2. Recommendation on Ricci Minor Subdivision - Limited Impact Review

STAFF REPORT

MEETING DATE: December 10, 2024

AGENDA ITEM TITLE: Ricci Minor Subdivision – Limited Impact Review

RICCI MINOR SUBDIVISION

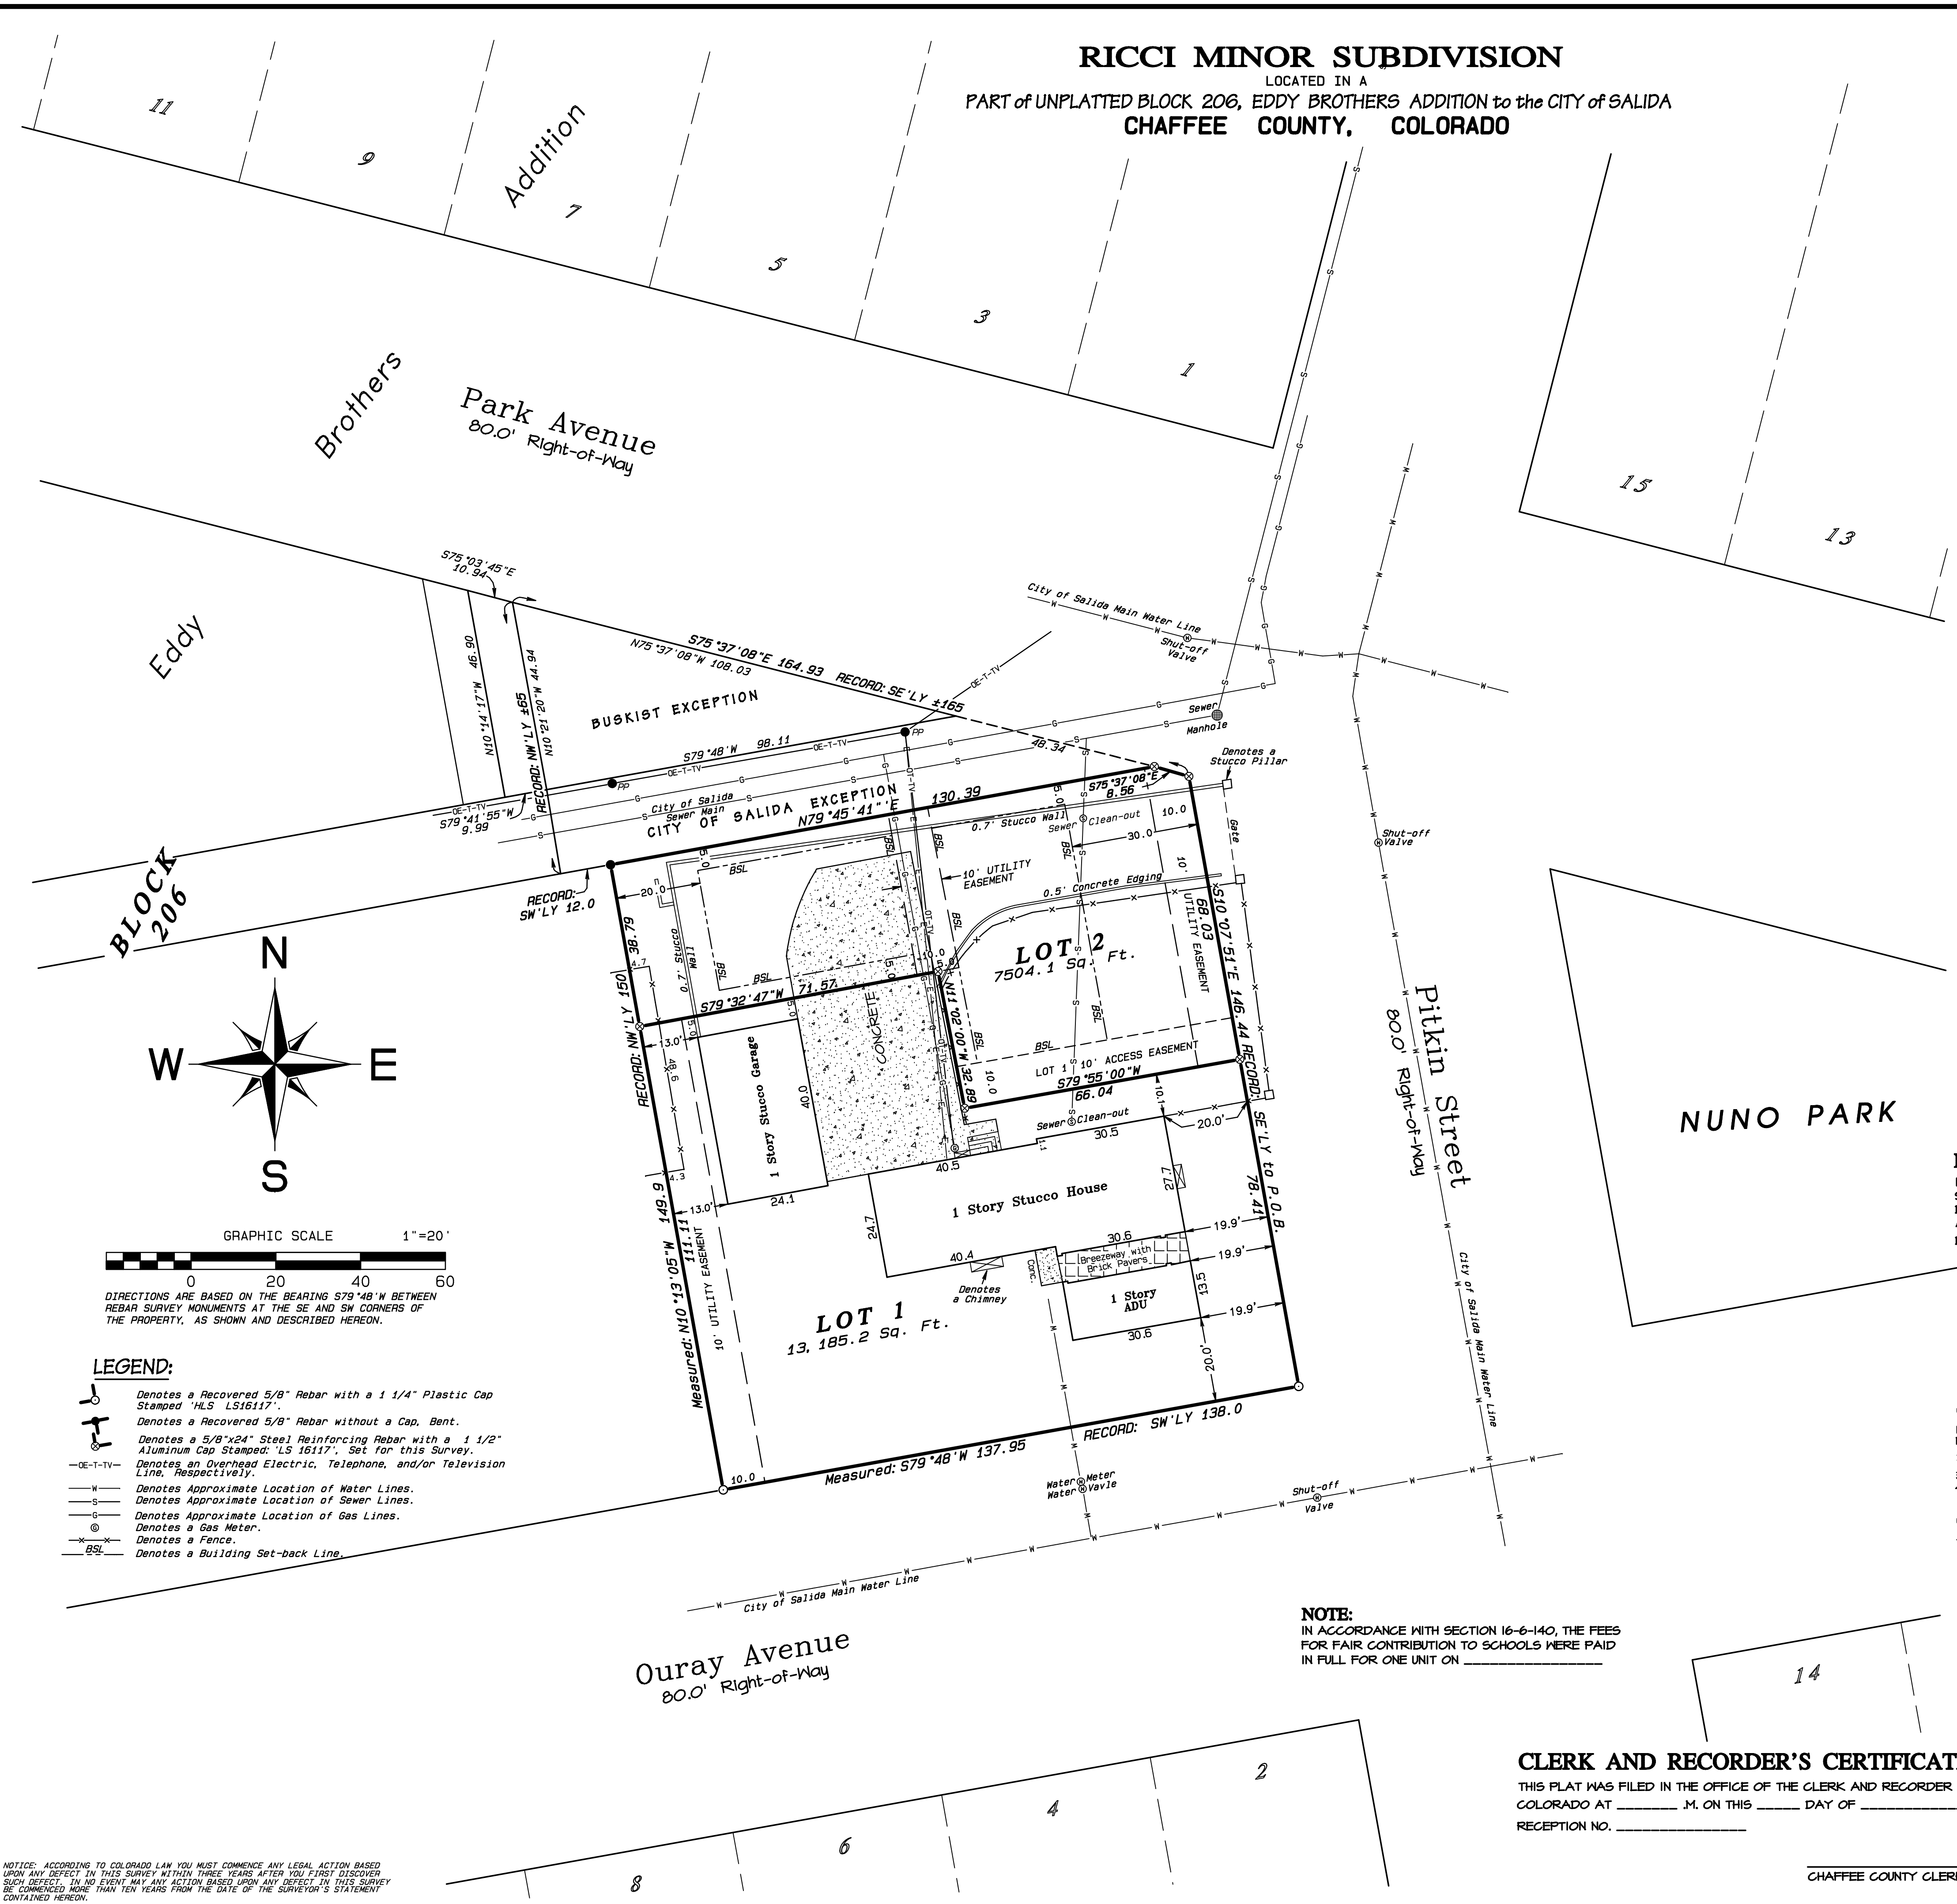
- 4) Xcel Energy has commented on the need for a utility easement across lot 2 of the subdivision, or rerouting of the lines. They stated the property owner/developer/contractor may either obtain an easement for this line or relocate the line. For an easement by separate Public Service Company document, a Right-of-Way Agent must be contacted.

- Xcel Energy has commented on the need for a utility easement or rerouting of electrical lines prior to development of Lot 2.
 - c. Phases. If the subdivision is to be developed in phases, each phase shall contain the required parking spaces, landscape areas, utilities and streets that are necessary for creating and sustaining a stable environment.'

Public Works Director, David Lady: Provide a five foot wide sidewalk, or a fee-in-lieu equal to the construction cost of the sidewalk, at the discretion of the PW Director.

Xcel Energy: “Public Service Company of Colorado’s (PSCo) Right of Way & Permits Referral Desk has reviewed the minor subdivision for Ricci Minor Subdivision and has a conflict with the lot split. Please be aware PSCo owns and operates existing overhead electric service facilities through Lot 2 to Lot 1. The lot split places the current service line in trespass through new Lot 2.

The property owner/developer/contractor may either obtain an easement for this line or relocate the line.

2. The applicant should confirm with Xcel Energy and Atmos Energy the appropriate width of the utility easement within the Lot 2 property, or relocate utilities as necessary, and amend the subdivision plat if necessary prior to recordation.

1. Provide the following notes on the minor subdivision plat prior to recording:
 - a. Utility easements are dedicated to the City of Salida for the benefit of the applicable utility providers for the installation, maintenance, and replacement of electric, gas, television, cable, and telecommunications facilities (Dry Utilities). Utility easements shall also be granted within any access easements and private streets in the subdivision. Permanent structures, improvements, objects, buildings, wells, water meters and other objects that may interfere with the utility facilities or use thereof (Interfering Objects) shall not be permitted within said utility easements and the utility providers, as grantees, may remove any Interfering Objects at no cost to such grantees, including, without limitation, vegetation. Public Service Company of Colorado (PSCo) and its successors reserve the right to require additional easements and to require the property owner to grant PSCo an easement on its standard form.

- d. Per Section 16-8-20 (e)(13)(i) A detached sidewalk of at least five (5) feet wide, with a thickness of at least four (4) inches of concrete, shall be installed along local streets in a limited impact review, or as determined by The Public Works Director, a fee-in-lieu be paid at time of development. This shall be added as a plat note.
